Sierra Forest Legacy

August 31, 2009

Re: Comments on Sugar Pine DEIS

These comments are submitted on behalf of Sierra Forest Legacy and the Sierra Club. We have reviewed the draft environmental impact statement, specialist reports, and reviewed marked units in the field for the Sugar Pine Project. Our comments focus largely on the potential impacts on fisher from the Proposed Action and alternatives. We offer the following comments for your consideration.

Figure 1. Approximate locations of female den buffers in the Sugar Pine project area in relation to treatment units. Taken from Switzer and Barrett (2009).

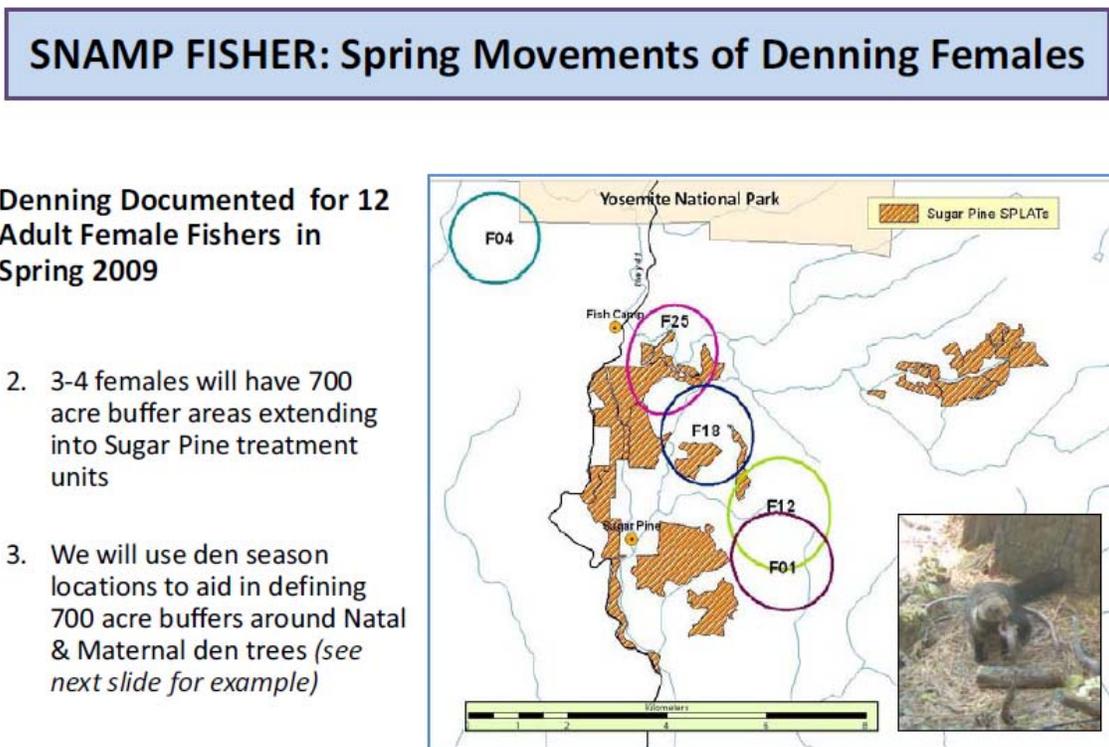
(BE, p. 75). The BE appears to be describing fisher occurrences during the 2008 season. However, results from surveys in 2009 indicate that several fishers are denning in the project area and that den buffers of approximately 700 acres overlap with treatment units (see Figure 1 below). This information was presented by Rick Switzer in May, 2009 and is posted on the SNAMP website.

We ask that this information and any other information on the specific use of the area by fisher be incorporated into the analysis of effects of the project on fisher.

Figure 2. Homes ranges of male and female fisher detected in 2009 in the Sierra Nevada Adaptive Management study area. This study area includes the Sugar Pine treatment units. Taken from Barrett and Sweitzer (2009).

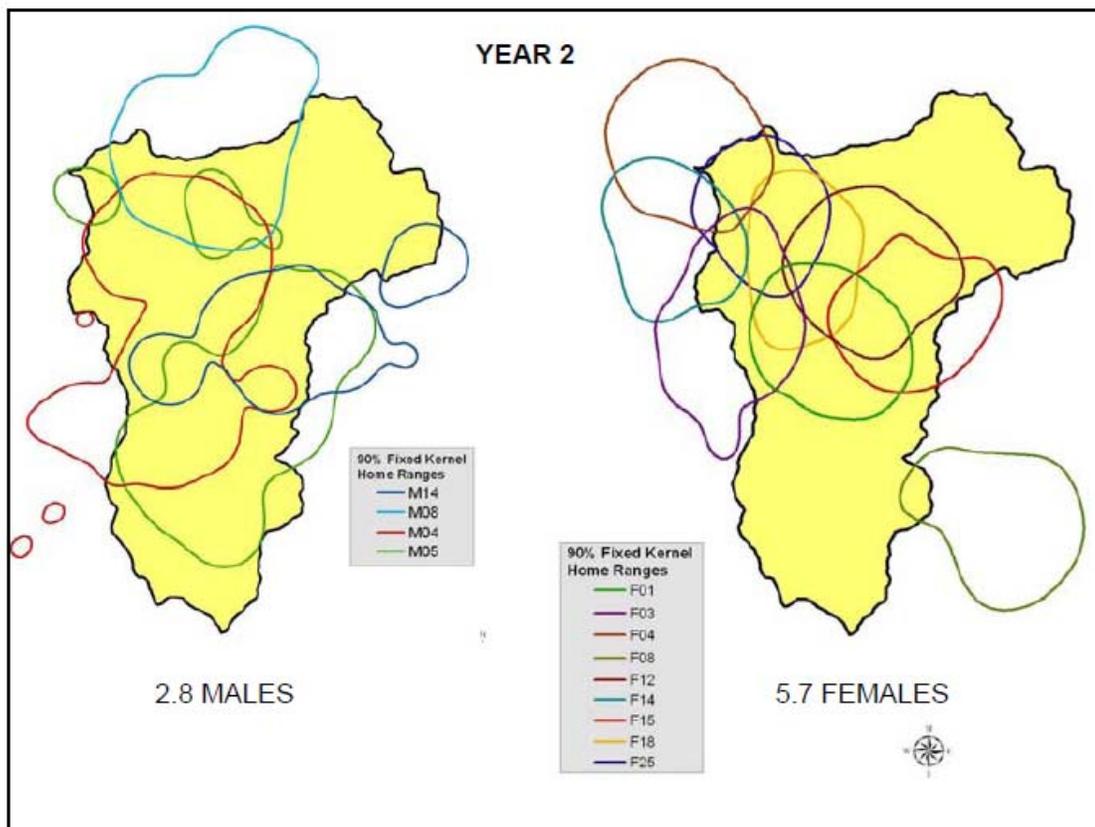
We are also aware that male fisher have been using the project area, but there is no mention of this in the BE or DEIS. The figure below (Figure 2) depicts the home ranges of males and

females detected during the 2009 season. Comparing this figure to the project area map for Sugar Pine it is clear that both males and females are currently using the Sugar Pine area.
